Technical Service Bulletin (TSB)

Fuel Filler Cap Tether Too Long

REFERENCE:	TSB: 14-004-23 GROUP 14 - Fuel System	Date:	July 1, 2023	REVISION:	14-010-21
VEHICLES AFFECTED:	2021 – **2023** (JL) Jeep Wrangler **This bulletin applies to vehicles built on or before March 15, 2023 (MDH 0523XX) equipped with a 2.0L I4 DOHC DI Turbo PHEV Engine (Sales Code ECX).**			MARKET APPLICABILITY: ☒ NA☒ MEA ☐ SA☒ IAP ☒ EE☐ CH	
CUSTOMER SYMPTOM:	Customers may experience a Malfunction Indicator Lamp (MIL) illumination. Upon further investigation the technician may find that one or more of the following Diagnostic Trouble Codes (DTCs) have been set: - P04EC - EVAP System Large Leak Detected - Fuel Tank Side. - P04EE - EVAP System Very Small Leak Detected - Fuel Tank Side. Customers may also comment the following: - There is a "Check Gas Cap" message in the Instrument Panel Cluster (IPC). NOTE: The above condition is caused from an air leak through the fuel filler cap and fuel filler neck seal, because the fuel filler cap tether is caught between both.

Fig. 1
Fuel Filler Cap Fastener And Tether

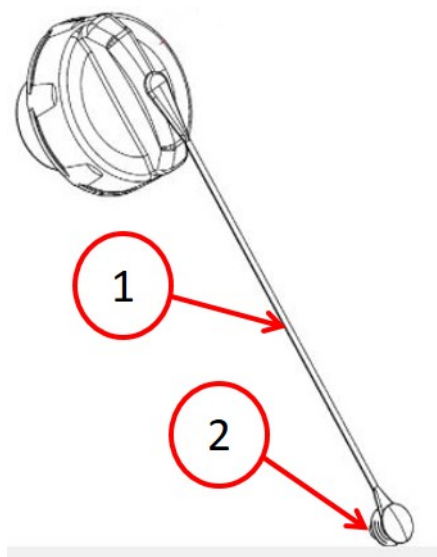
1. Open the fuel filler door.
2. Using a trim stick tool, remove the fuel filler cap tether fastener (Fig. 1) from the vehicle.

3. Remove the fuel filler cap (Fig. 1) from the filler tube.
4. **Cut the existing tether near the base that is mounted in the back of housing and discard cap/tether (Fig. 1) .
5. Replace the tappet base on the fuel door with the new part.

6. Install tether onto the new mounting provision on the new tappet base.**
7. Install the new fuel filler cap tether (Fig. 1) on the fuel filler cap.
8. Install the fuel filler cap (Fig. 1) on the filler tube.
9. Close the fuel filler door and verify there is no binding with the tether.
10. Clear any DTCs that may have been set.
